SHOP FACILITY

GRANT COUNTY
PUBLIC WORKS DEPARTMENT
ROAD DISTRICT NO. 3
QUINCY, WASHINGTON

AS BUILT DRWG'S

ADDENDUM NO. 1
ATTACHMENT No. 1

DATE	07-12-04
DRAWN	JPC
CHECKED	DAS
PROJECT NUMBER	04-42-029
DRAWING NO.	C2.0

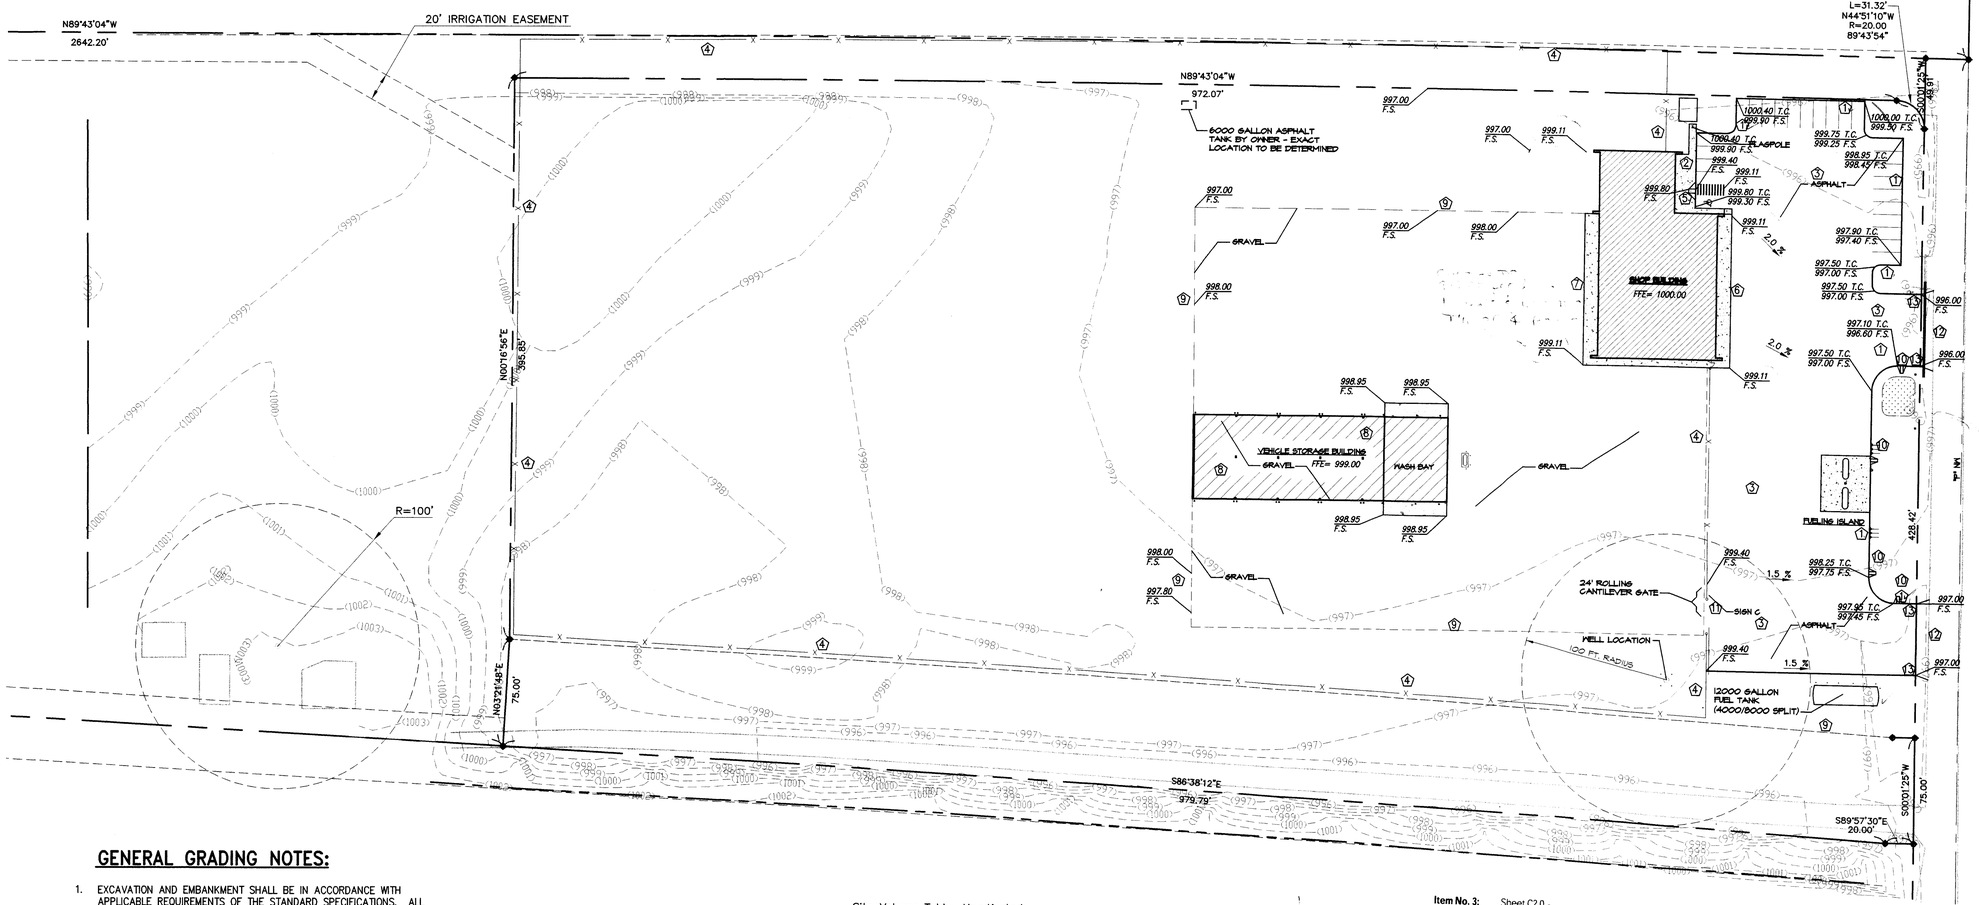
Item No. 3: Sheet C2.0 -
Depth of gravel drives, including gravel in Vehicle Storage Building, is 6".

DATE	07-12-04
DRAWN	JFC
CHECKED	DAS
PROJECT NUMBER	04-42-029
DRAWING NO.	C2.0

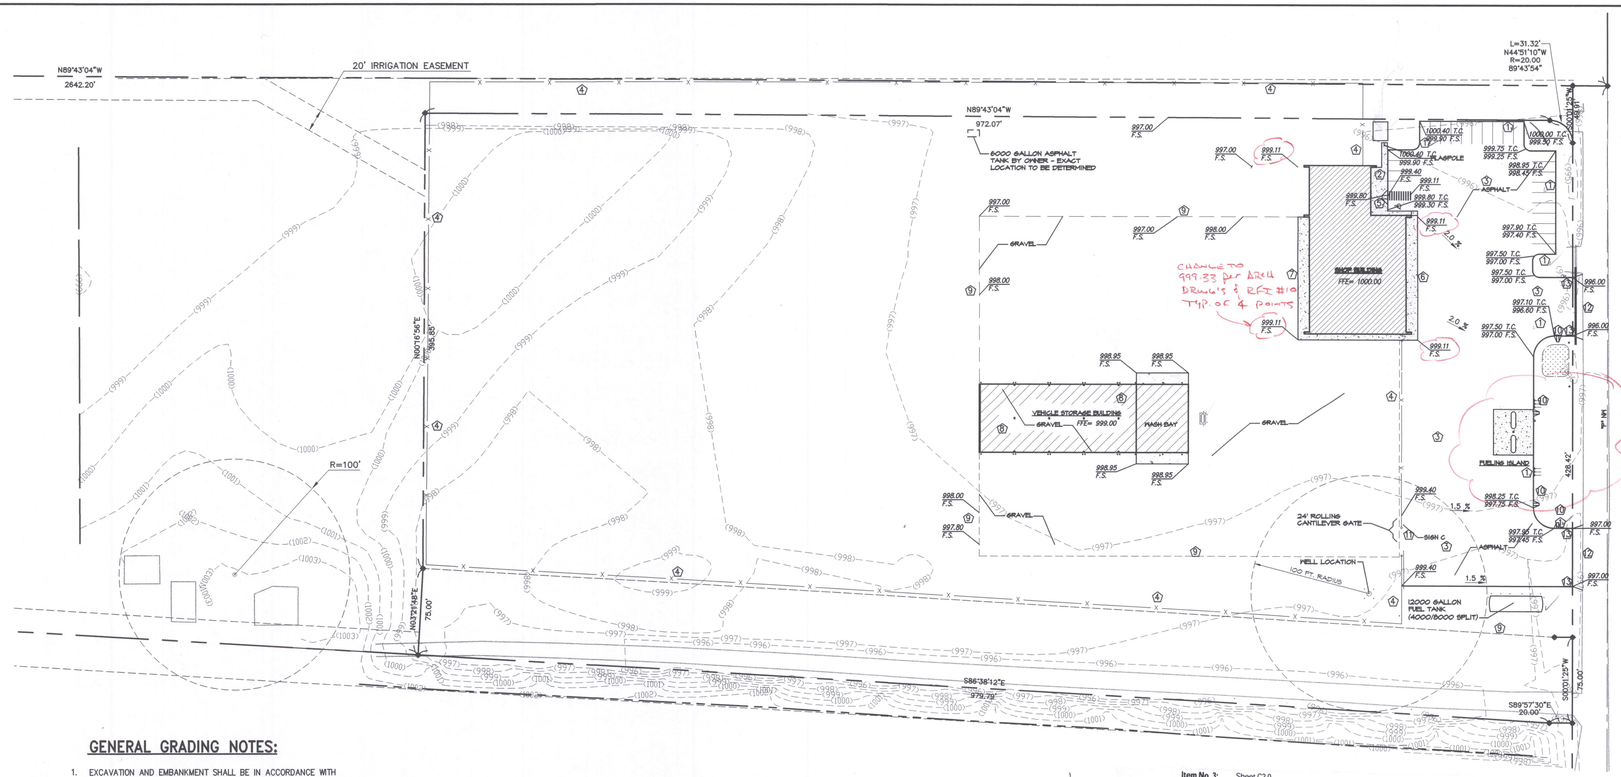
Item No. 3: Sheet C2.0 -
Depth of gravel drives, including gravel in Vehicle Storage Building, is 6".

DATE	7/12/04
DRAWN	TG
CHECKED	WAF/RFW
PROJECT NUMBER	0415
DRAWING NO.	AS1.1

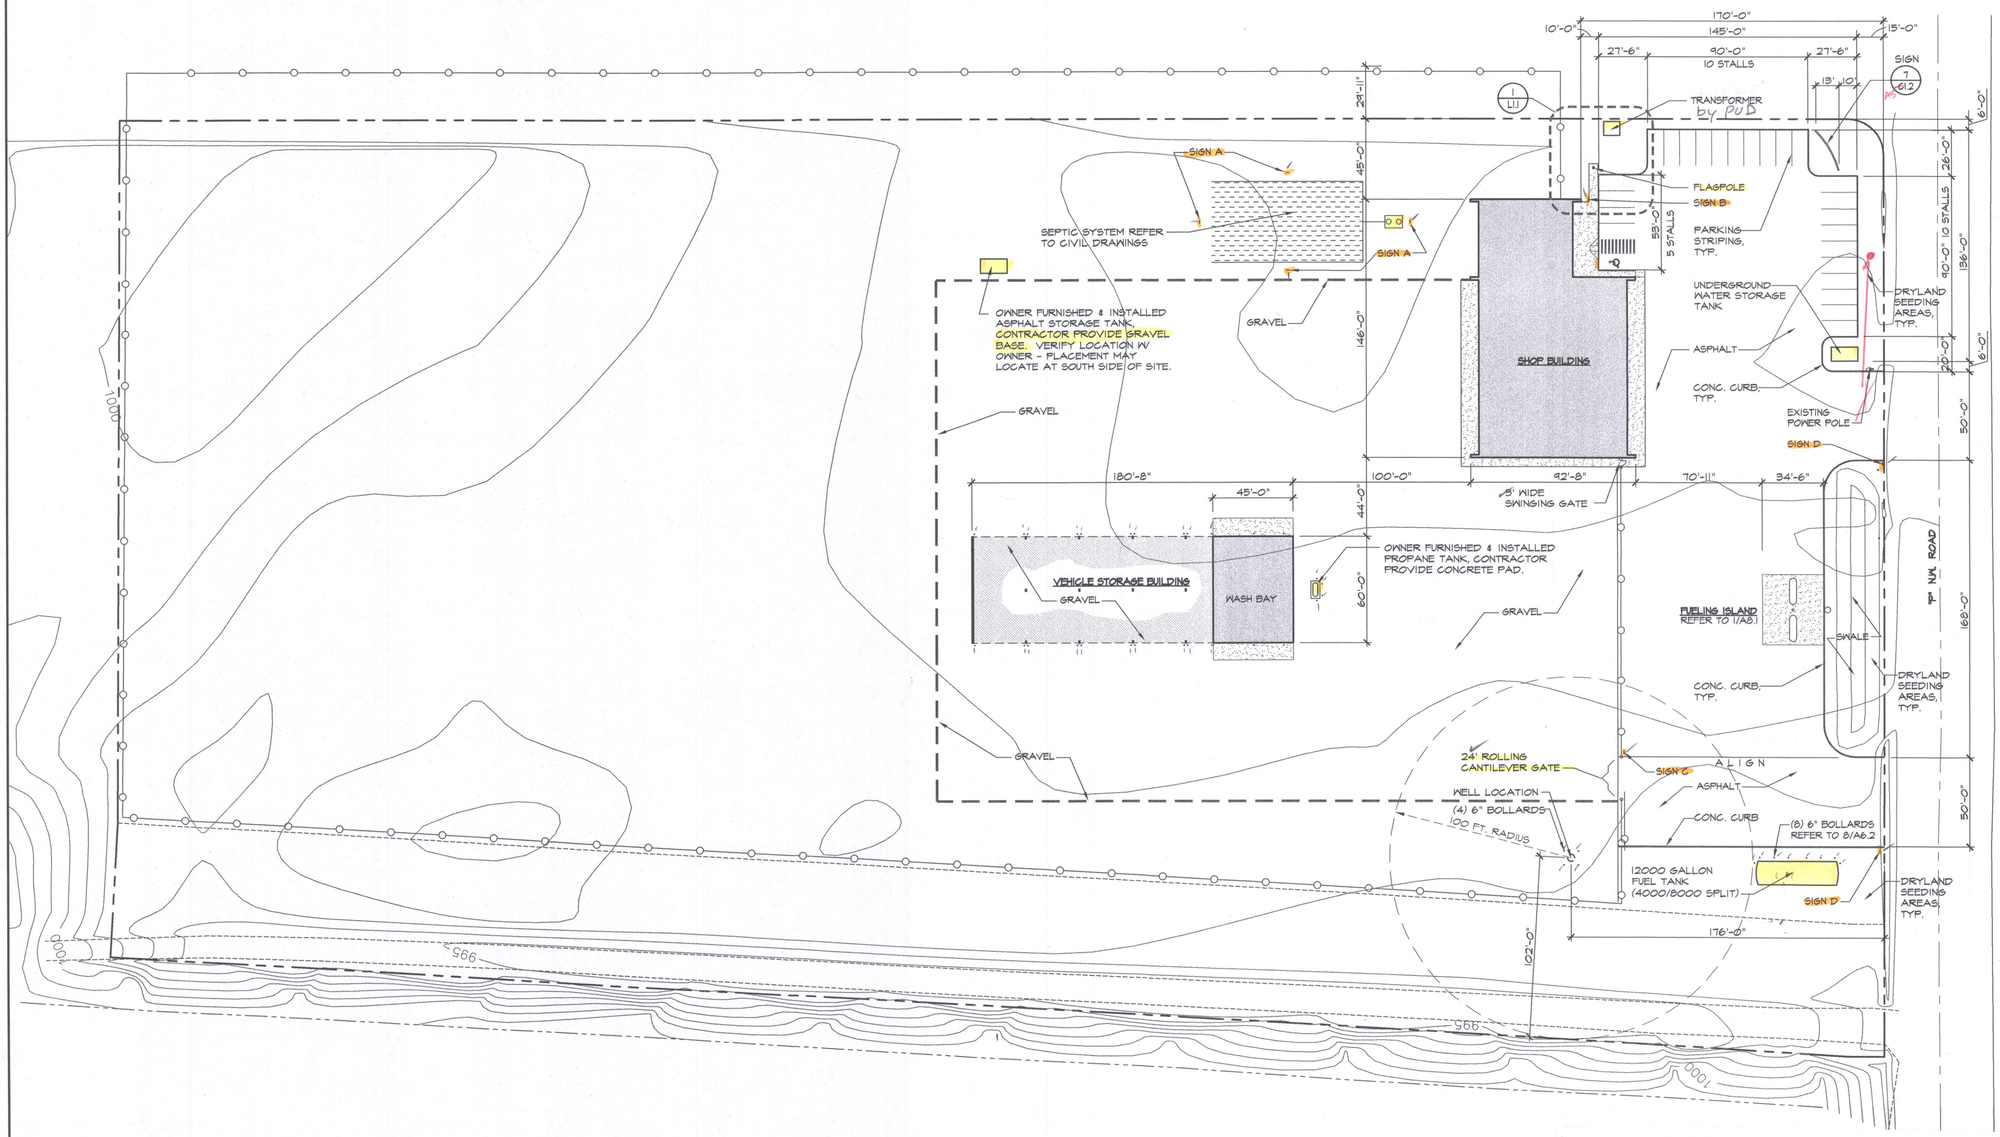
Item No. 4: Sheet AS1.1 - Site Plan:
Fencing, as indicated by line with spaced circles (refer to Sheet C2.0, Reference Note 4) is chain link fencing, 8'-0" height without privacy slats or barb-wire top.

1 LANDSCAPE PLAN DETAIL

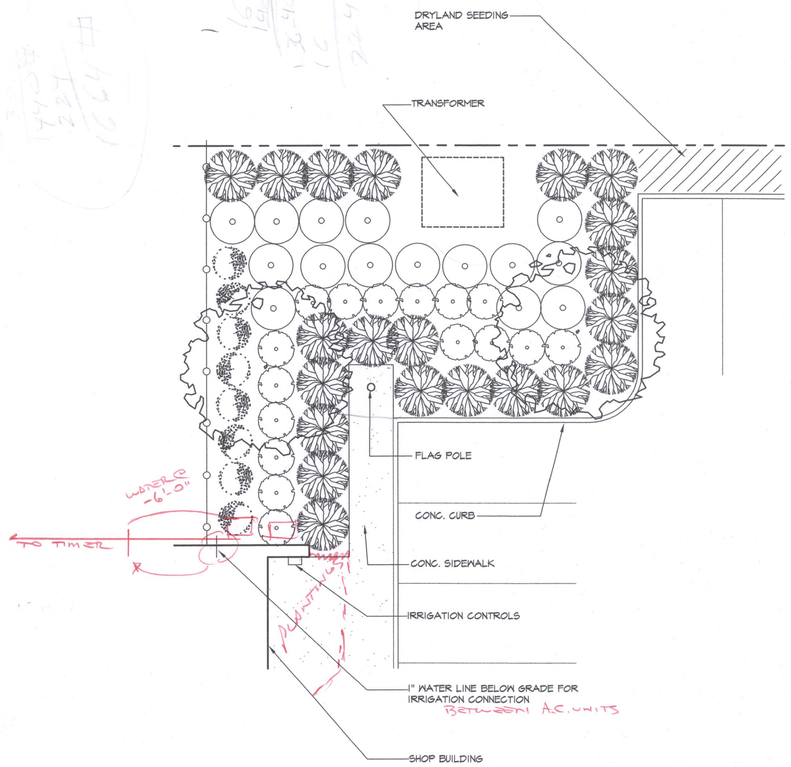
Item No. 6: Sheet L.1.1 -Plant Legend:
Change quantity of plants as follows:
TCC - (2), CDL - (14), EAC - (8), SBA - (16), BJ -(21). PFT are not used.

VEHICLE STORAGE BUILDING-ROOF PLAN

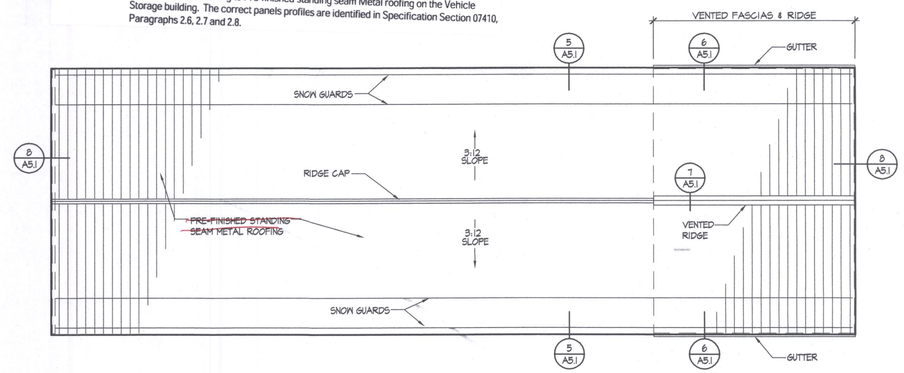
Item No. 8: Sheet A5.1 - Vehicle Storage Building Roof Plan:
Delete the note referring to Pre-finished standing seam Metal roofing on the Vehicle Storage building. The correct panels profiles are identified in Specification Section 07410, Paragraphs 2.6, 2.7 and 2.8.

DATE	7/12/04
DRAWN	RSV/TG
CHECKED	WAF/RFW
PROJECT NUMBER	0415
DRAWING NO.	A8.1

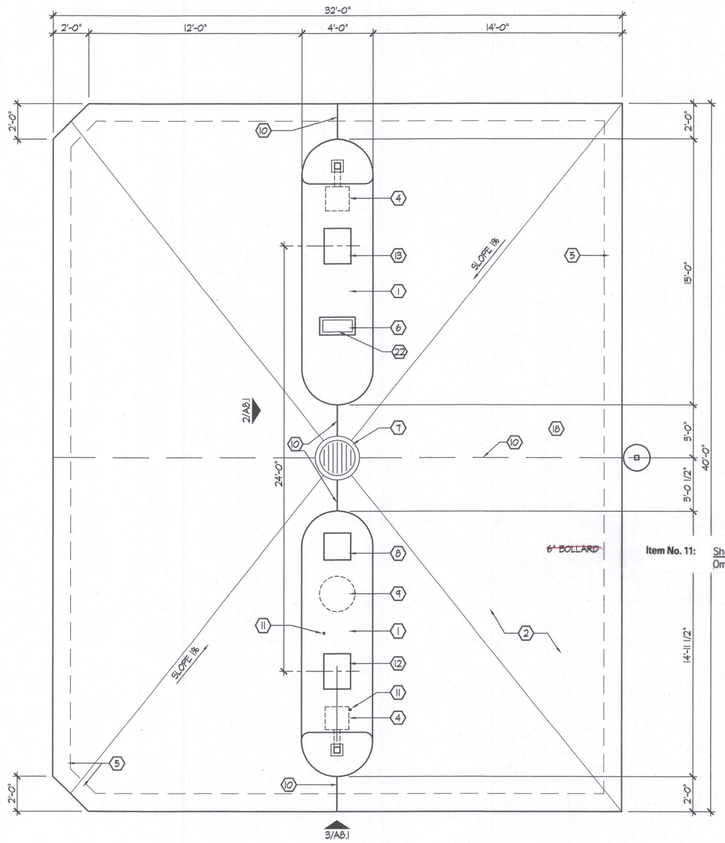
Item No. 11: Sheet A8.1 - Fuel Island Plan: Omit any reference to 6" bollard.

DATE	7/12/04
DRAWN	SSK
CHECKED	GAD
PROJECT NUMBER	0415
DRAWING NO.	S2.1

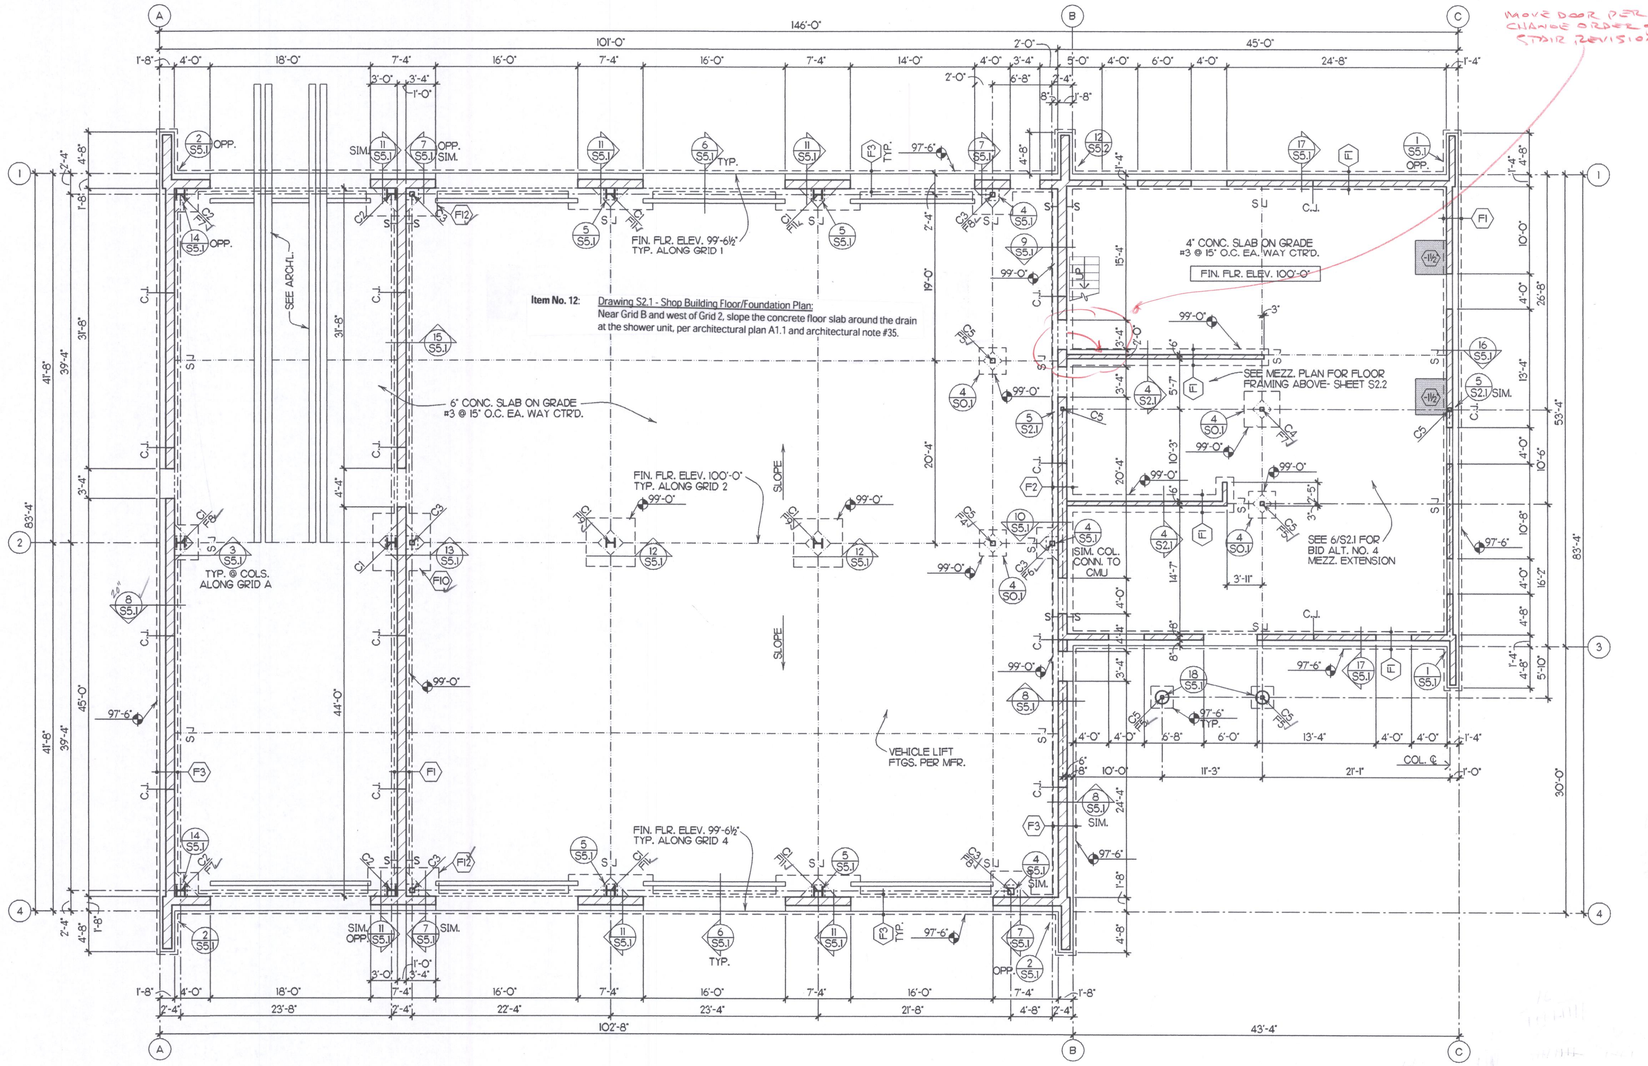
Item No. 12: Drawing S2.1 - Shop Building Floor/Foundation Plan: Near Grid B and west of Grid 2, slope the concrete floor slab around the drain at the shower unit, per architectural plan A1.1 and architectural note #35.

MOVE DOOR PER CHANGE ORDER & STAIR REVISIONS

DATE	7/12/04
DRAWN	SSK
CHECKED	GAD
PROJECT NUMBER	0415
DRAWING NO.	S2.3

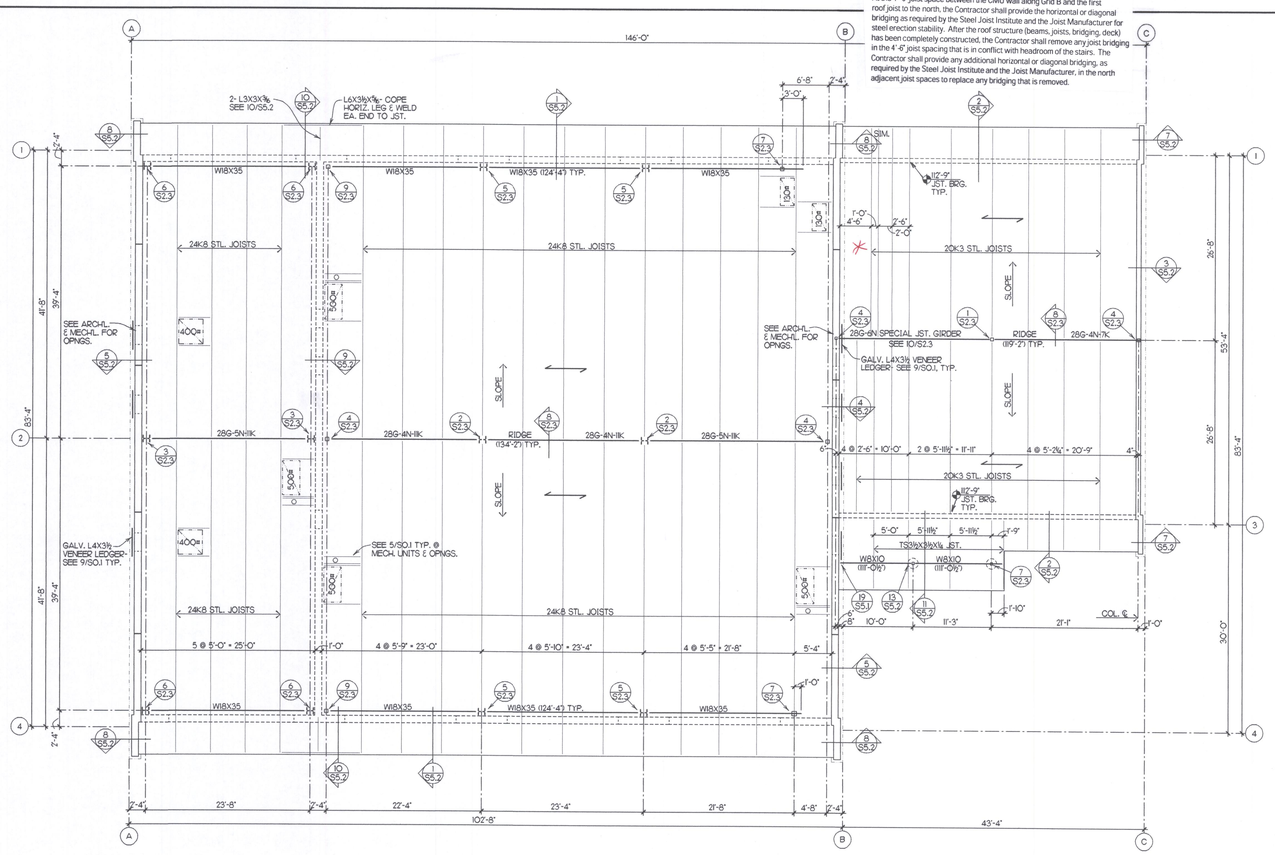
Item No. 13: Drawing S2.3 - Shop Building Roof Framing Plan:
At the 4'-6" joist space between the CMU wall along Grid B and the first roof joist to the north, the Contractor shall provide the horizontal or diagonal bridging as required by the Steel Joist Institute and the Joist Manufacturer for steel erection stability. After the roof structure (beams, joists, bridging, deck) has been completely constructed, the Contractor shall remove any joist bridging in the 4'-6" joist spacing that is in conflict with headroom of the stairs. The Contractor shall provide any additional horizontal or diagonal bridging, as required by the Steel Joist Institute and the Joist Manufacturer, in the north adjacent joist spaces to replace any bridging that is removed.

DATE	04/02/04
DRAWN	DMK
CHECKED	DRN
PROJECT NUMBER	0415
DRAWING NO.	E0.2

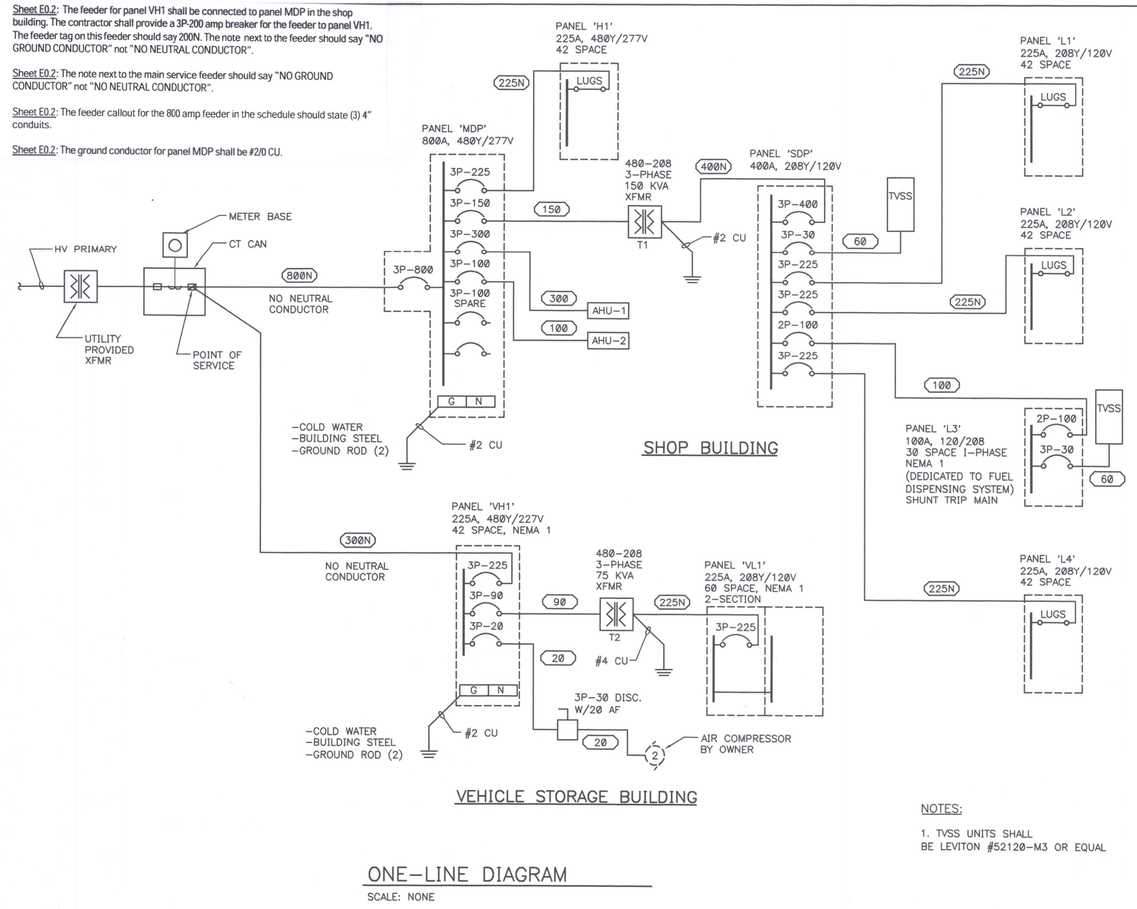
Item No 16: Sheet E0.2: The feeder for panel VH1 shall be connected to panel MDP in the shop building. The contractor shall provide a 3P-200 amp breaker for the feeder to panel VH1. The feeder tag on this feeder should say 200N. The note next to the feeder should say "NO GROUND CONDUCTOR" not "NO NEUTRAL CONDUCTOR".

Item No 17: Sheet E0.2: The note next to the main service feeder should say "NO GROUND CONDUCTOR" not "NO NEUTRAL CONDUCTOR".

Item No 18: Sheet E0.2: The feeder callout for the 800 amp feeder in the schedule should state (3) 4" conduits.

Item No 19: Sheet E0.2: The ground conductor for panel MDP shall be #2/0 CU.

Item No 26: Sheet E0.2: The j-boxes called out in the heat mat connection diagram to be flush mounted may be surface mounted. All exposed conduit in shop and welding bay from the floor surface to +24" must be continuous galvanized rigid steel.
